SUBJECT: Docket No. 50-602, Request for Renewal of Facility Operating License R-129

RE: University of Texas at Austin – Request for Additional Information Regarding the License Renewal
Request For the Nuclear Engineering Teaching Laboratory TRIGA Mark II Nuclear Research Reactor
(TAC NO. ME7694)

Attached is a response to Requests for Additional Information including:

Figure 1, UT TRIGA Reactor Core

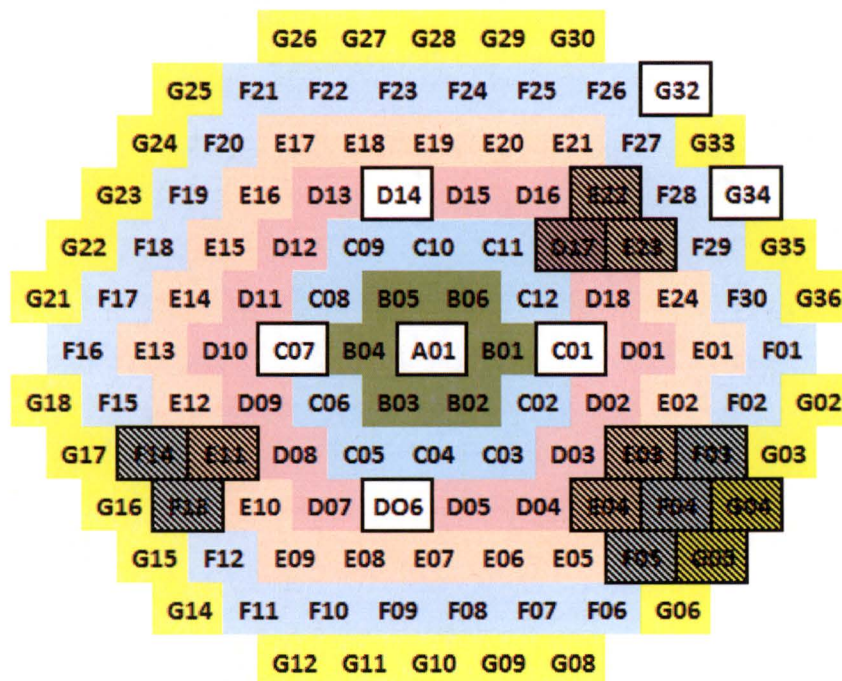
8.1 Please provide schematic drawings showing the location of fuel elements, control rods, and other components installed in the lettered-and-numbered lattice positions.

See response to RAI 7, Figure 1
